| 2. AMENDMENT/MODIFICATION NO. 0003 | | 3. EFFECTIVE DATE 03/26/2012 | | 4. REQUISITION/PURCHASE REQ. NO. | | 5. PROJECT NO. (If applicable) |
| 8. NAME AND ADDRESS OF CONTRACTOR (No., street, county, State and ZIP Code) | | | | <input checked="" type="checkbox"/> 9A. AMENDMENT OF SOLICITATION NO. DTFAWN-12-R-00053 9B. DATED (SEE ITEM 11) 03/01/2012 | | |

This amendment is issued to answer questions that were received prior to March 21, 2012, and clarify Amendment No. 0002.

Here are room schedules for a standard design level levels 1 & 2, typical levels with elevator landings and between landings. Typical levels are designated by room numbers beginning with the letter "X". Level 10 & 11'.

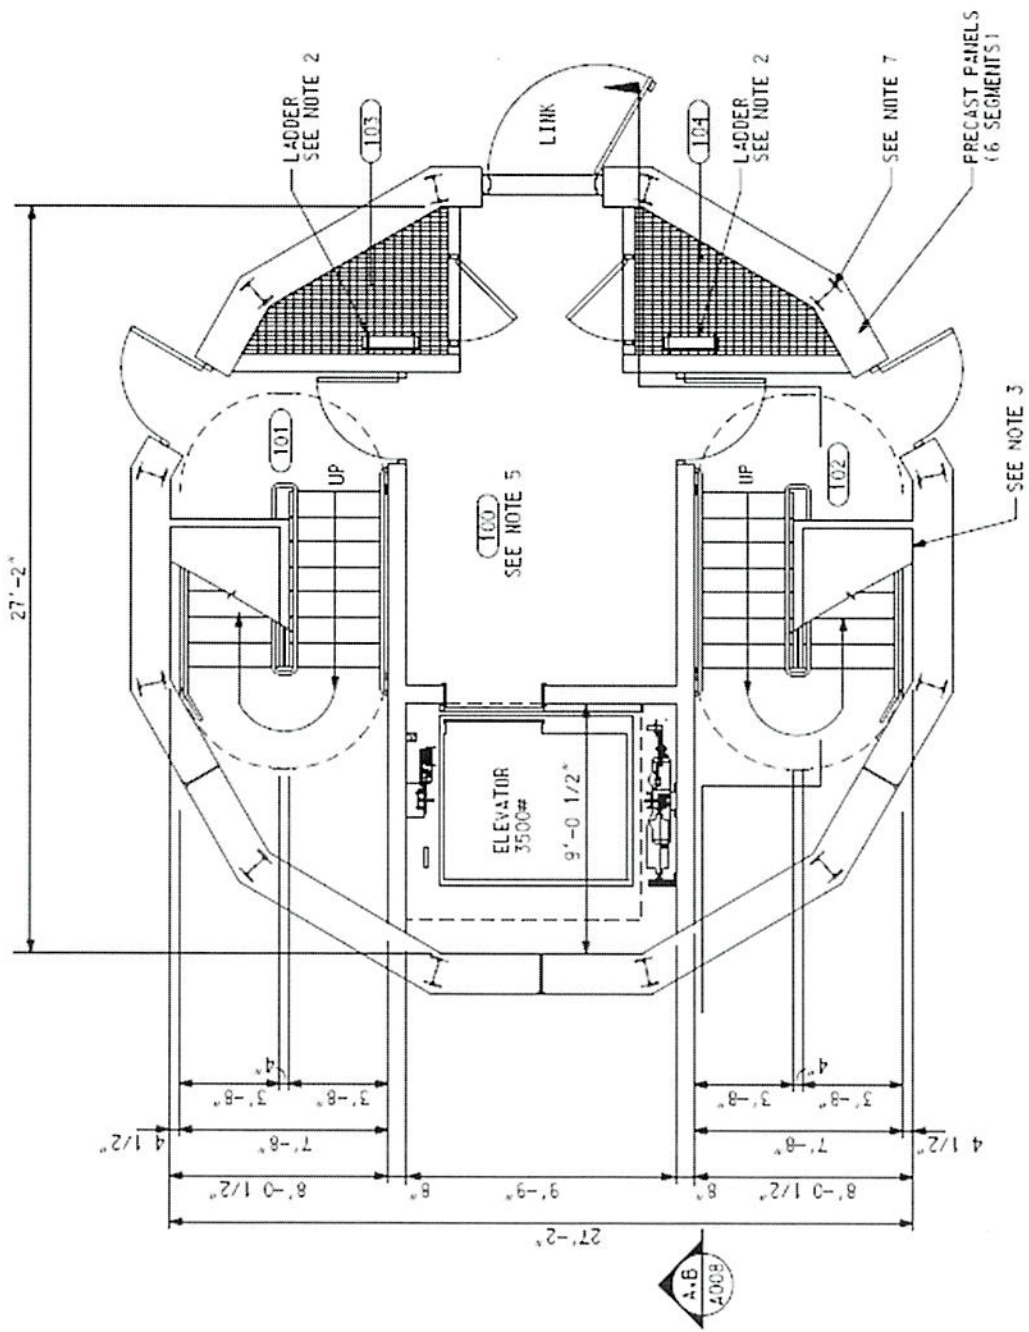
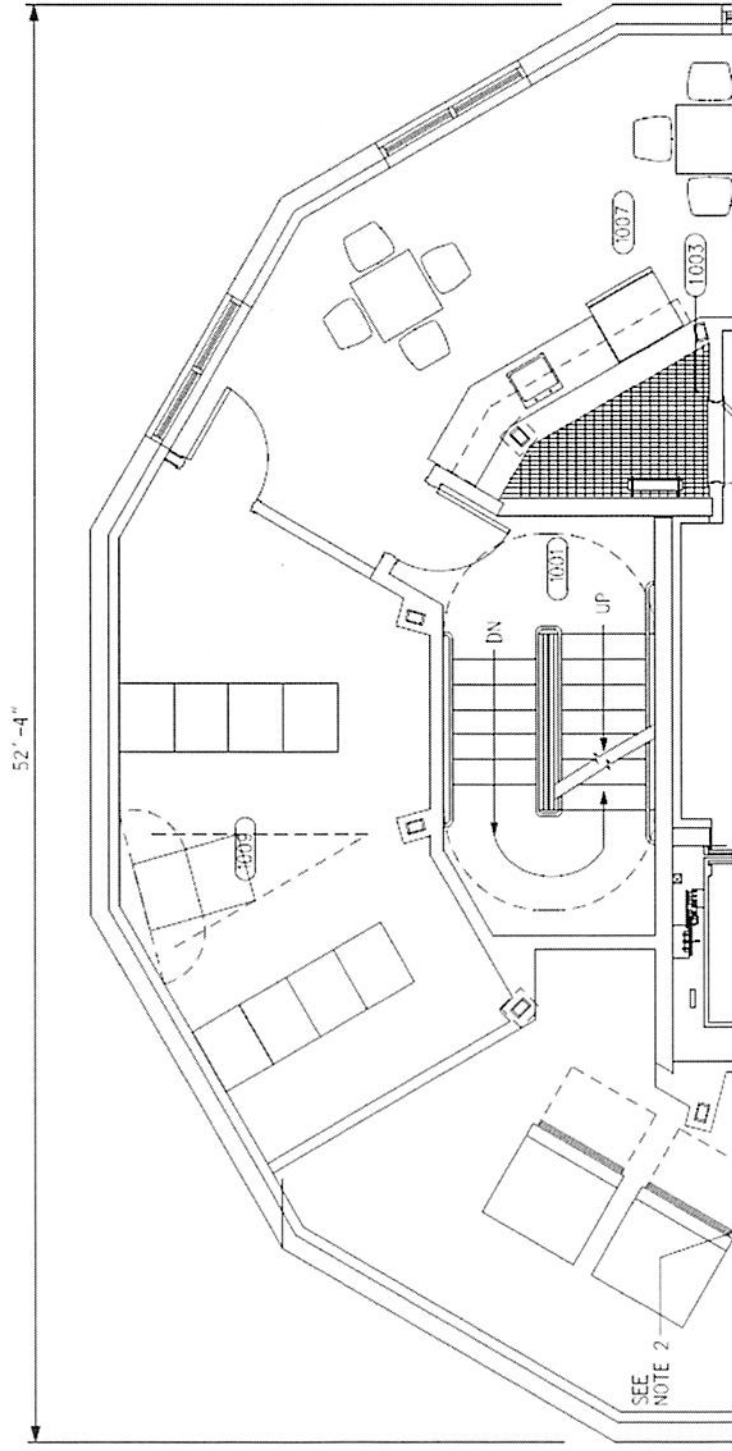
8. Page 21. Please provide the space allocation chart of the ATCT called for in Paragraph 5.3.

The room schedules for each level can be found on the KSN site.

Room sizes are not supplied and will be determined during the design process. The standard design contains the following dimensions for reference:
